Angel Way - Response to Design Comments

Job: 1393-GSA-DGZ-XX-RP-A-0001
date: 14/11/2025
Rev: P02

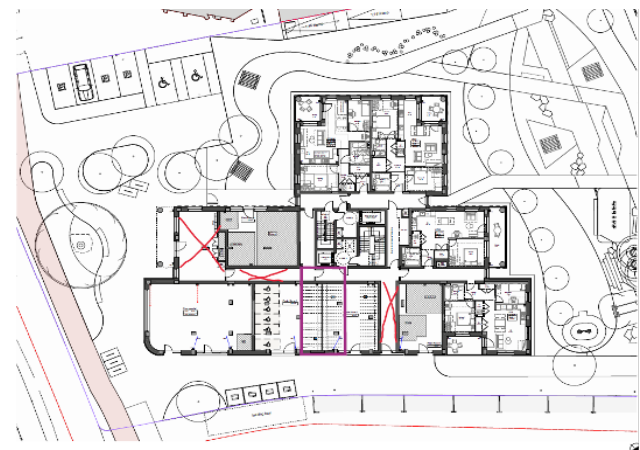
2.2 The proposed Block A ground floor has excessive circulation and should be rationalised – for example, a centralised lobby opening on to Angel Way could free up ground floor area – see sketch below. NB this could be rationalised further by creating individual front doors to ground floor units rather than accessing from a central corridor.

Of the five ground floor flats, only one flat (A-00-04) could have direct access from the public highway to an individual front door. The other 4 flats could only be accessed via the private communal garden, making access for visitors and deliveries more challenging and potentially compromise the security of the communal garden. The introduction of individual front doors would mean entering a ground floor dwelling directly into the main living area, which would compromise the efficiency of the internal layout.

What is shown on the adjacent mark up of the ground floor plan would remove the generous communal lobby to the west and the secondary access from Angel Way south. This would result in having just a narrow corridor leading from the street to the stair and lift core. This would result in a low-grade entrance experience and overall feel of a low level, low value development.

Having a pleasant and relatively generous entrance helps create a good ambience for the development and adds value, as increasingly, new developments are required to deliver resident spaces for meeting, sitting, working, socialising.

The removal of the entrance lobby and a secondary access may create more space but not sufficient for a new dwelling. The space would end up being given over to ancillary storage/plant room and result in a lower quality entrance experience and development overall.
